SUPPLEMENTAL INSTRUCTION

PROJ.: **Boys and Girls Club Prince of Wales**
PROJ. No.: **1716**
DATE: **Jan 26, 2018**
S.I. No. **S.I. - 009**

Information Bulletin S02-A

1. Title: STRUCTURAL REVISIONS

DRAWING
FOUNDATION PLAN

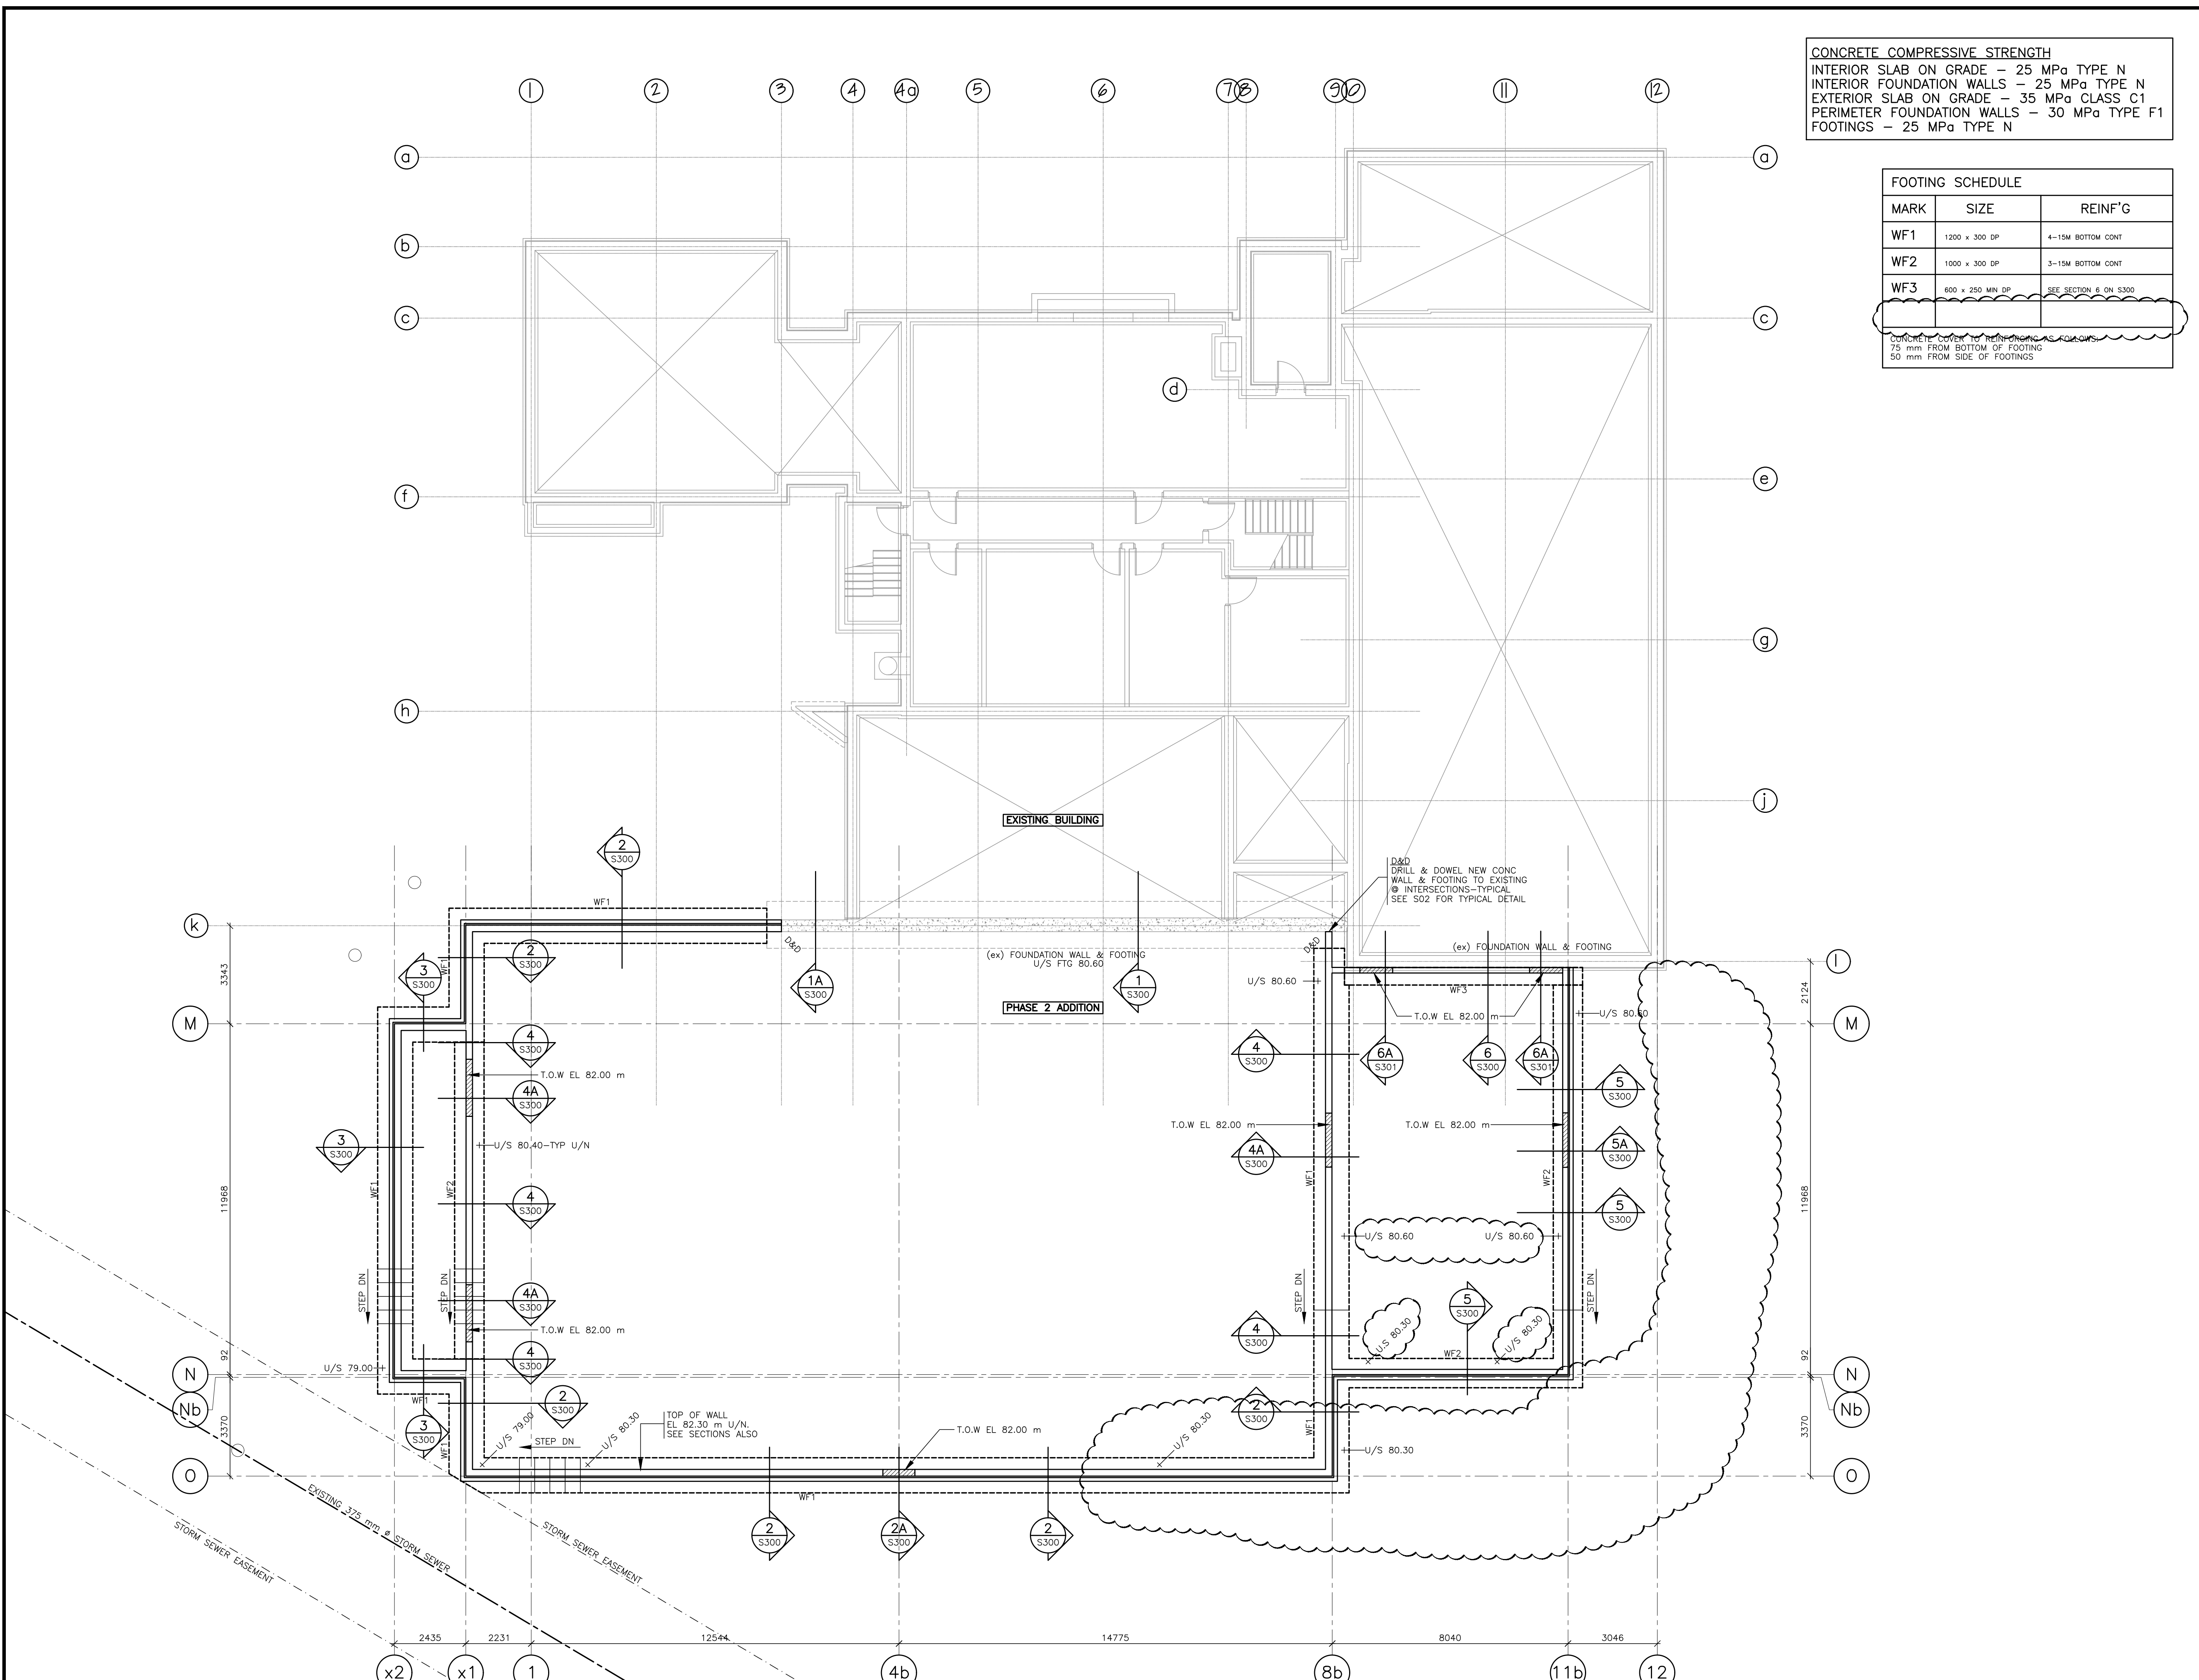
- .1 S00 SEISMIC DATA – REVISIONS ARE CLOUDED
- .2 S01 GENERAL NOTES – REVISIONS ARE CLOUDED
- .3 S02 TYPICAL DETAILS – REVISIONS ARE CLOUDED
- .4 S100 FOUNDATION PLAN – REVISIONS ARE CLOUDED
- .5 S101 GROUND FLOOR PLAN – REVISIONS ARE CLOUDED
- .6 S102 ROOF PLAN – REVISIONS ARE CLOUDED
- .7 S300 SECTIONS & DETAILS – NO REVISIONS
- .8 S301 SECTIONS & DETAILS – REVISIONS ARE CLOUDED
- .9 S302 SECTIONS & DETAILS – REVISIONS ARE CLOUDED

The revisions in this Information Bulletin are part of a cost saving exercise. The major revisions are the change of the gym roof structure from Glulam beams to steel joists and the deletion of the exterior concrete ramps, stairs & foundations. There are however additional cost saving revisions throughout the drawings in this package. Please read in conjunction with the Architectural drawings.
